SUBJECT: ISSUANCE OF AMENDMENT NOS. 69 AND 51 TO FACILITY OPERATING LICENSE  
NOS. NPF-11 AND NPF-18 - LASALLE COUNTY STATION, UNITS 1 AND 2  
(TAC NOS. 71995 AND 71996)

The amendments revise the LaSalle County Station, Units 1 and 2 Technical Specifications by revising the MAPLHGR Limits Curves to reflect the higher nodal exposures values for specific fuel types.

SAFETY EVALUATION BY THE OFFICE OF NUCLEAR REACTOR REGULATION  
SUPPORTING AMENDMENT NO. 69 TO FACILITY OPERATING LICENSE NO. NPF-11 AND  
AMENDMENT NO. 51 TO FACILITY OPERATING LICENSE NO. NPF-18  
COMMONWEALTH EDISON COMPANY  
LASALLE COUNTY STATION, UNITS 1 AND 2  
DOCKET NOS. 50-373 AND 50-374

Figure 3.2.1-1

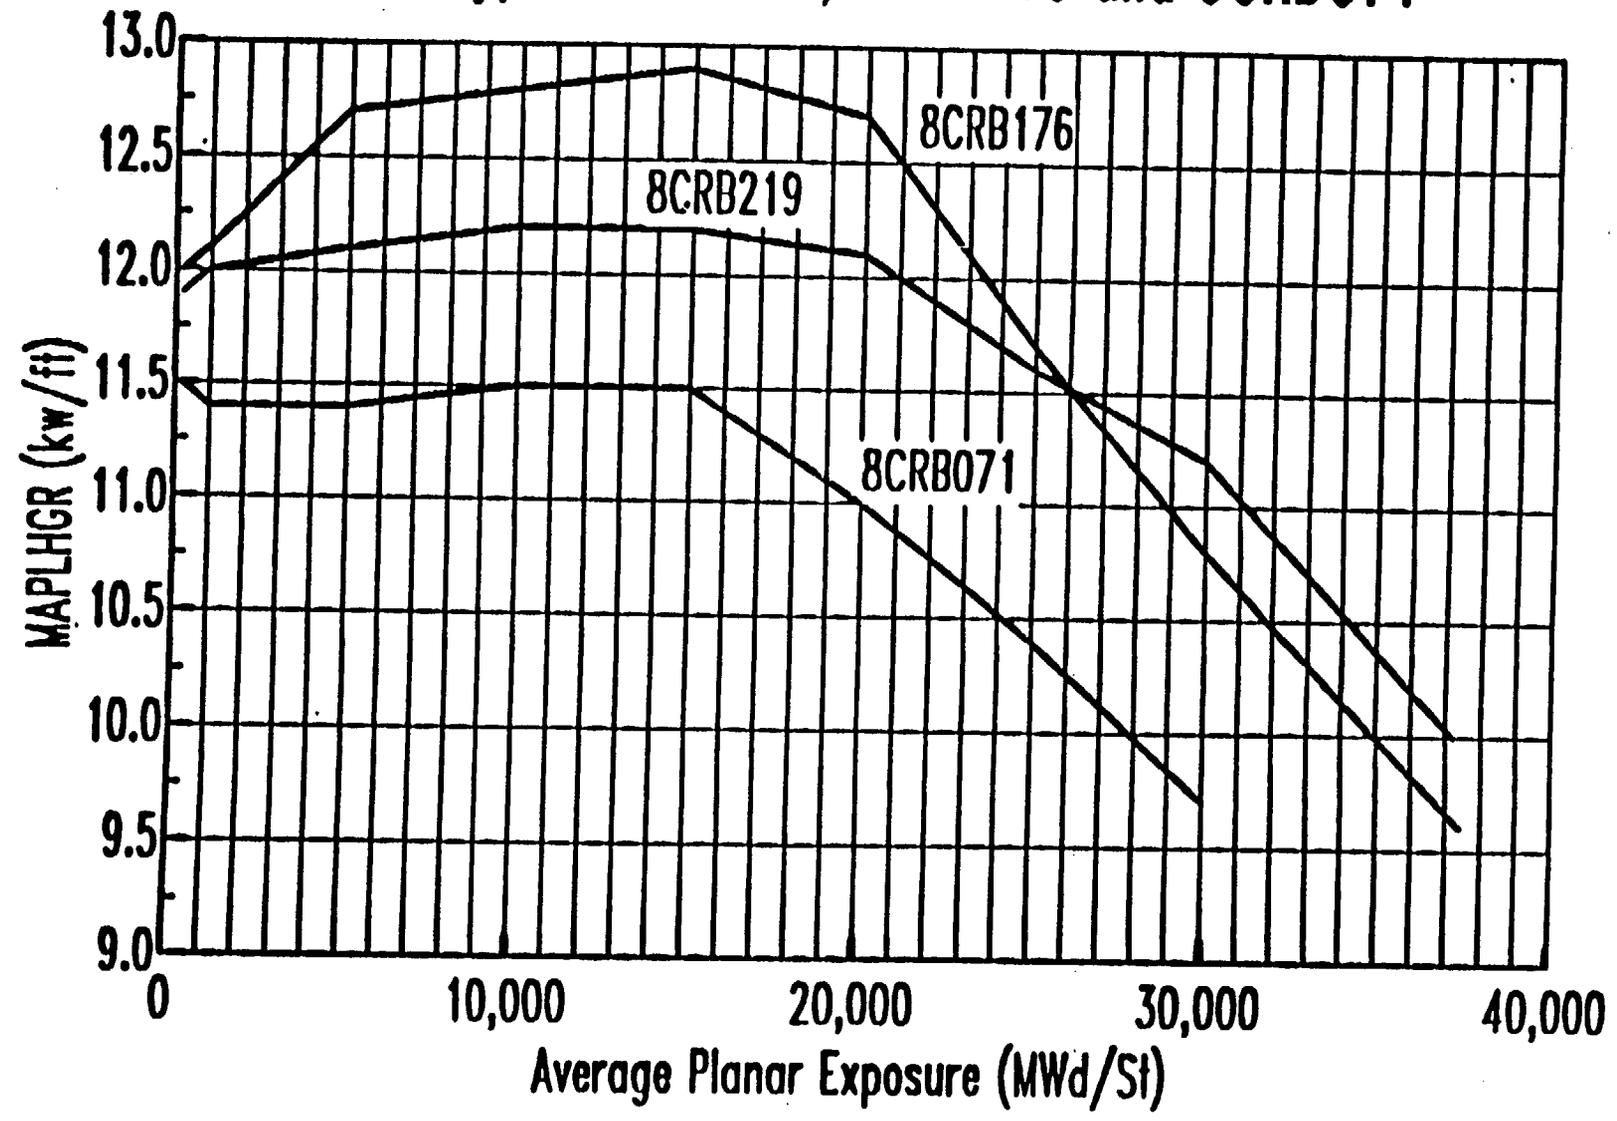
# MAPLHGR VS. Average Planar Exposure Fuel Types 8CRB176, 8CRB219 and 8CRB071

Figure 3.2.1-2

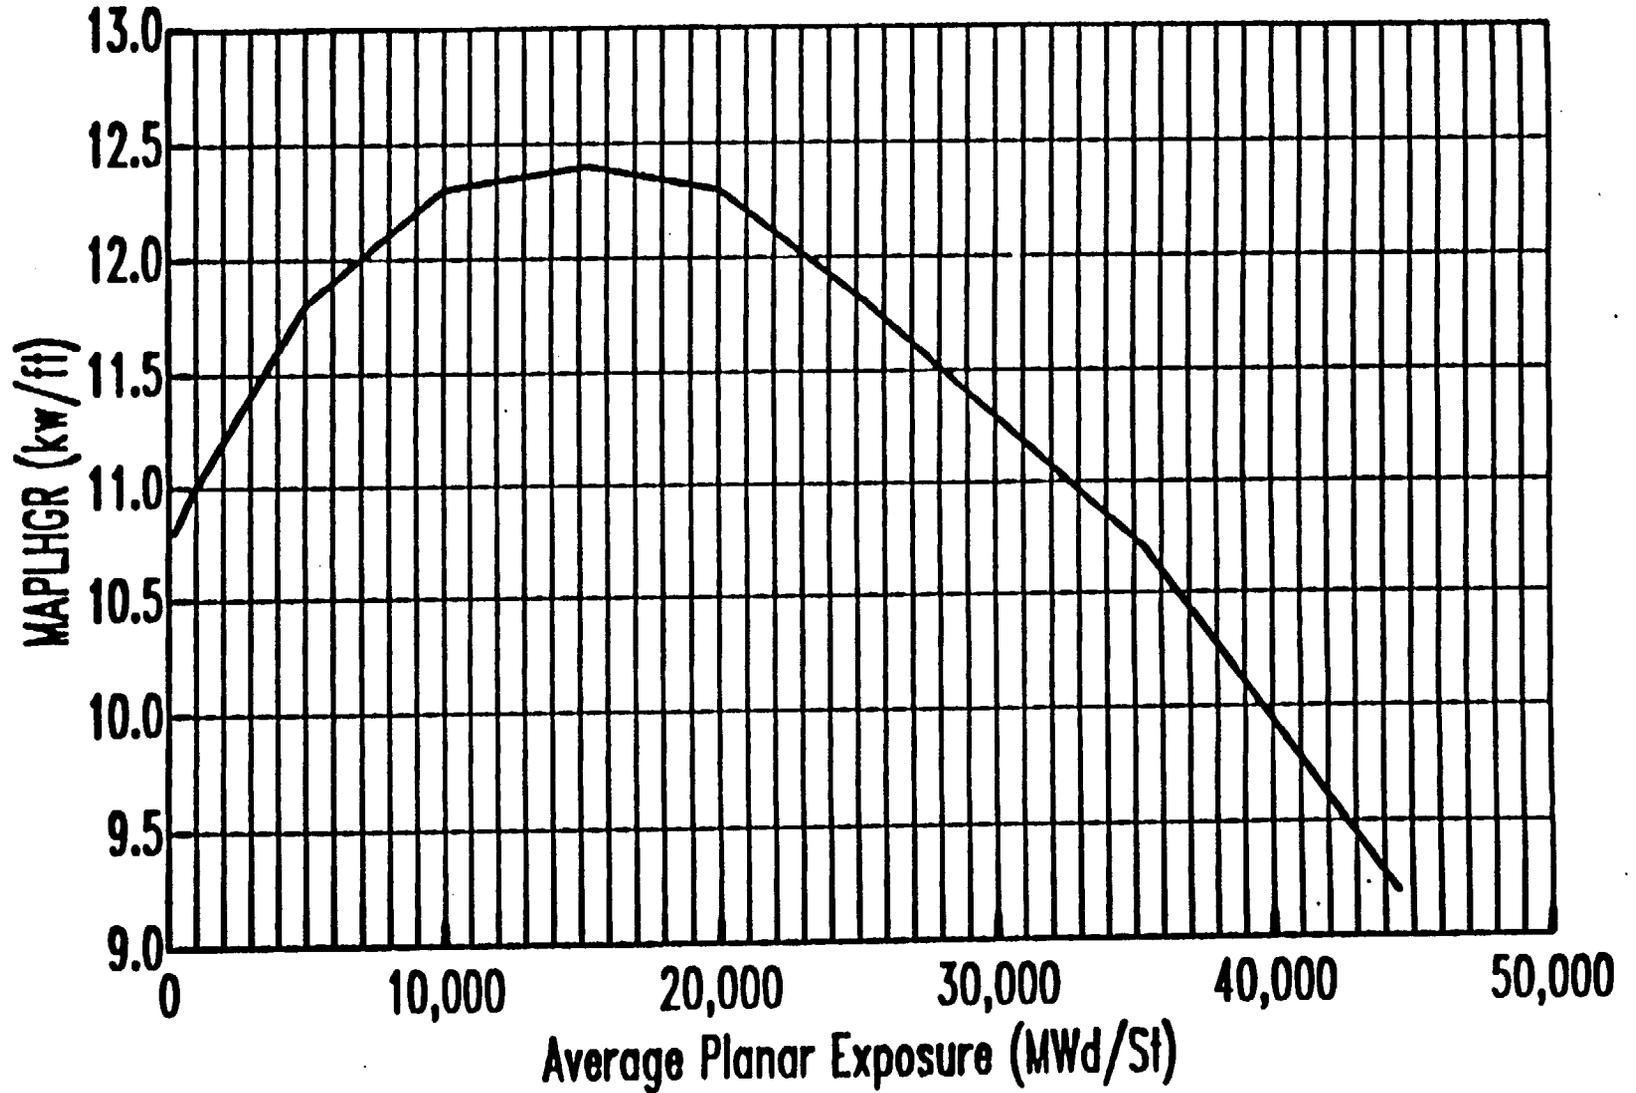
# MAPLHGR VS. Average Planar Exposure Fuel Type BP8CRB299L

Figure 3.2.1-1

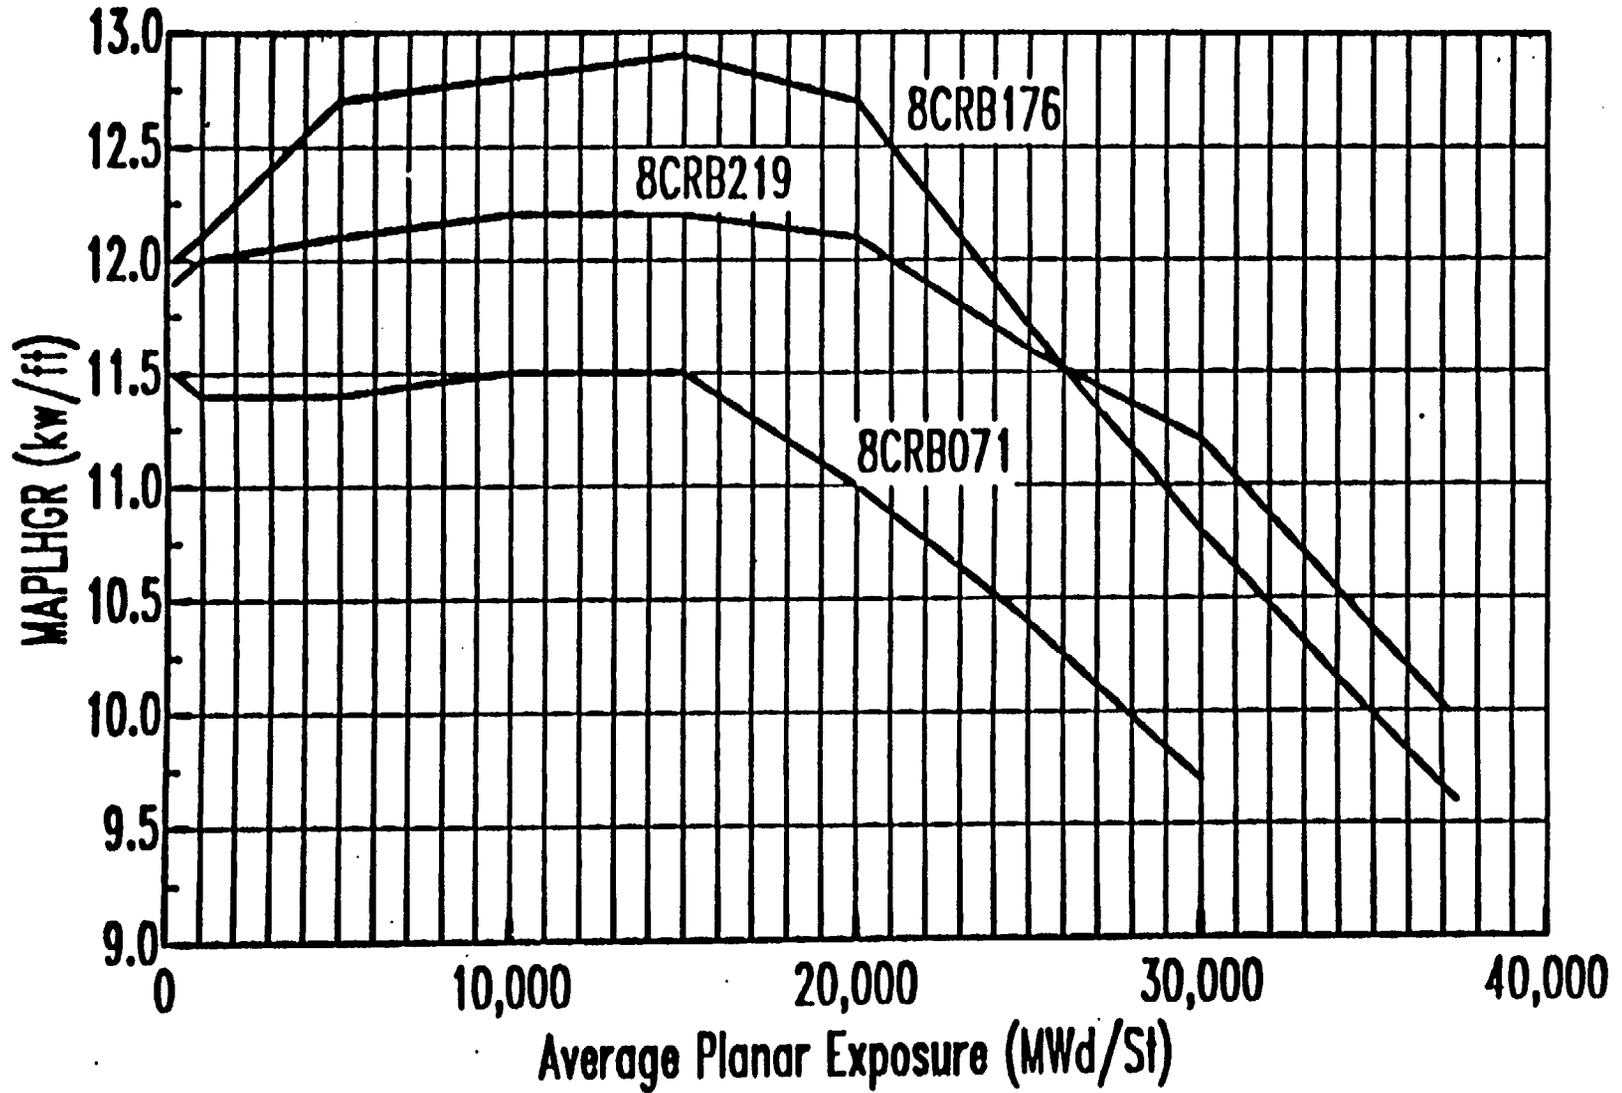
# MAPLHGR VS. Average Planar Exposure Fuel Types 8CRB176, 8CRB219 and 8CRB071

Figure 3.2.1-2

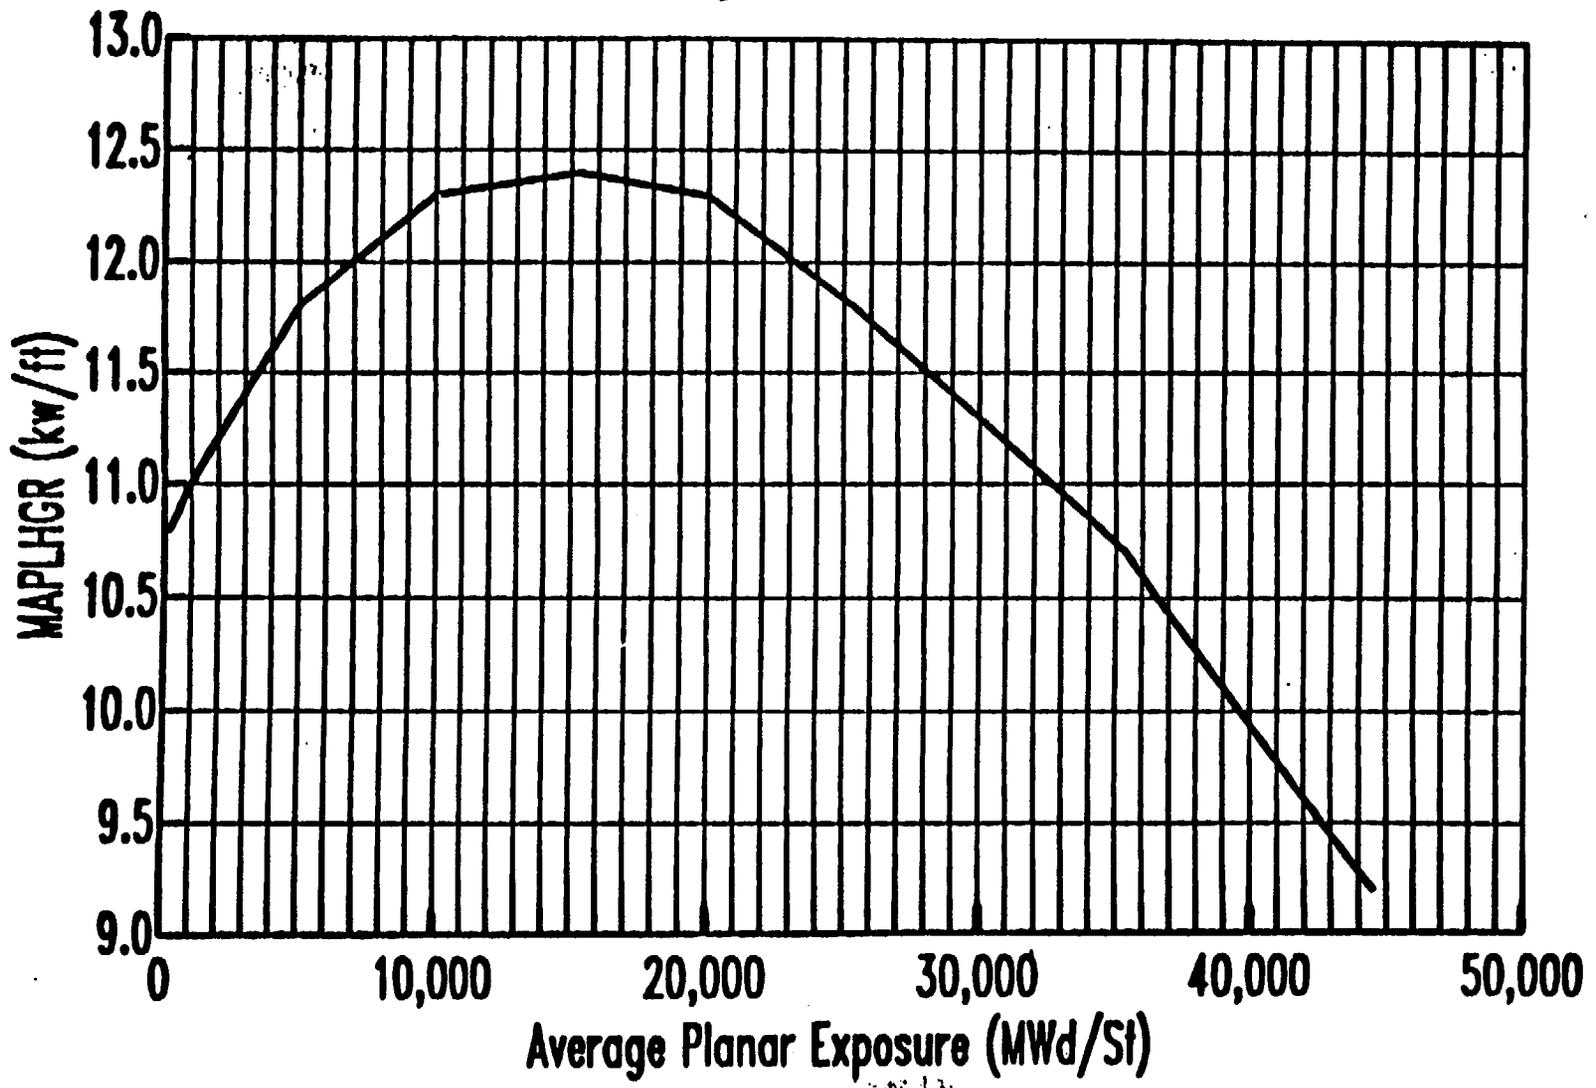
# MAPLHGR VS. Average Planar Exposure Fuel Type BP8CRB299L
